SYCAMORE TRAILS AQUATIC CENTER IMPROVEMENT PROJECT

ADDENDUM #2

FEBRUARY 12, 2025

ITEM #4: Plumbing, Utilities, and Pathways

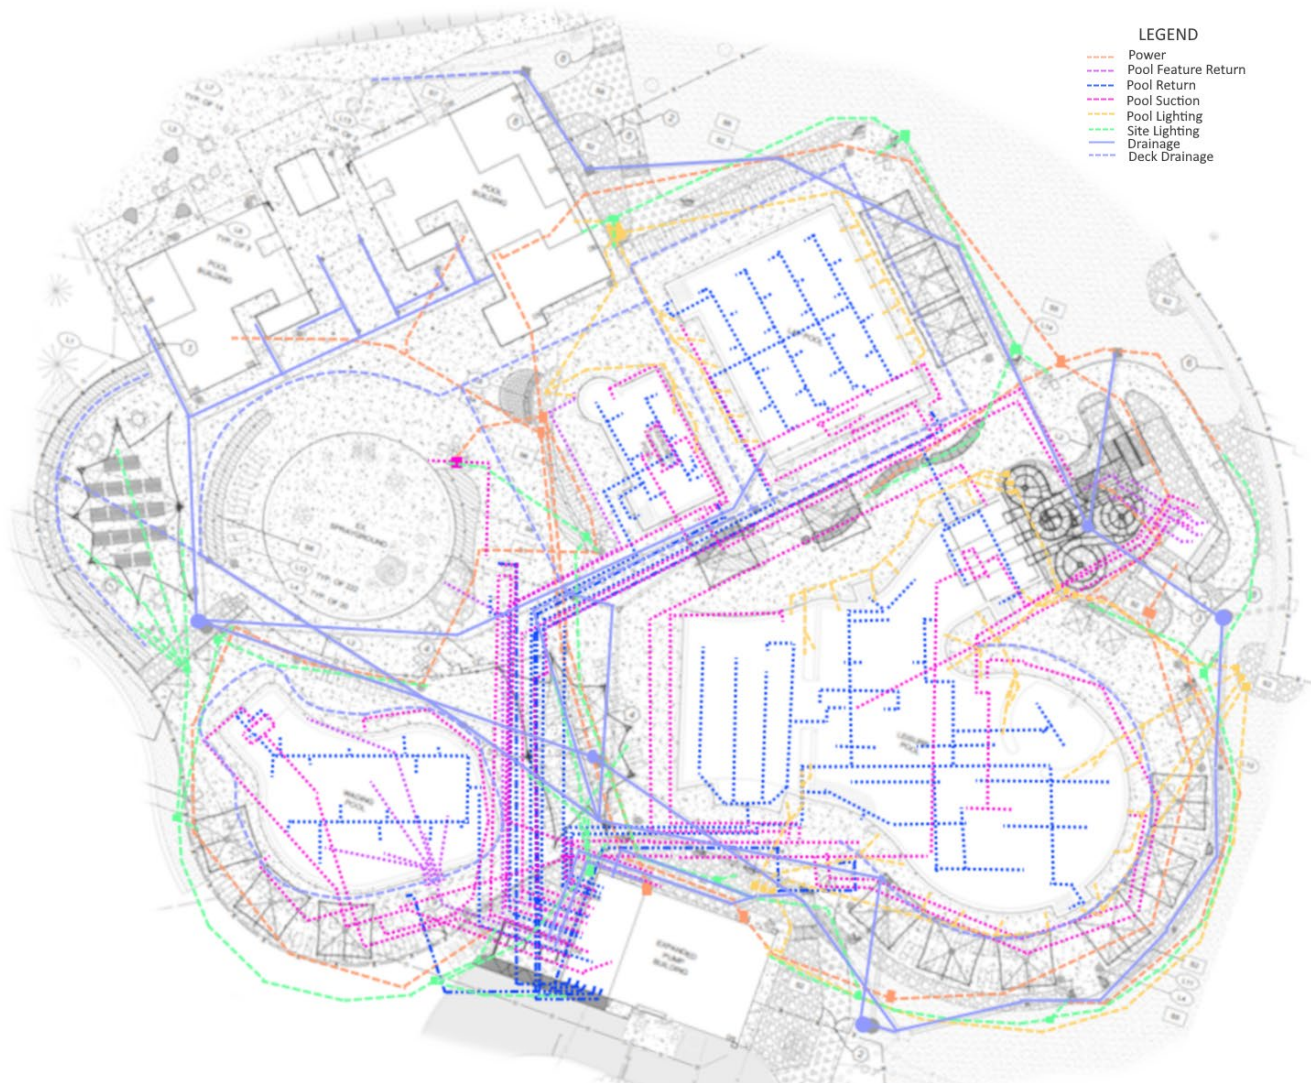
In response to a request for issuance of a drawing overlaying the pool plumbing, site utilities, and conduit pathways on one drawing to help bidders better understand conflicts, coordination, phasing and mobilization, the Owner has created the following graphic. Means and methods are the responsibility of the awarded GC. Construction drawings show design intent only and not true availability of on-site pathways for the utilities. Per the drawings and specifications, it is the responsibility of the awarded GC to create the infrastructure overlay map as part of a discipline coordination process – this map is to be reviewed with all the affected sub-contractors, Owner, and Design Team in a master underground utility infrastructure coordination meeting prior to commencement of the new underground work. To be reviewed at this meeting include but not limited to the following items: Conflicts, Routing deviations from the design intent and possible solutions, Phasing of work. The graphic below is a visual representation of the potential pathways, but should be noted is preliminary and draft format, is not to scale, nor intended to be interpreted as anything other than for reference only.
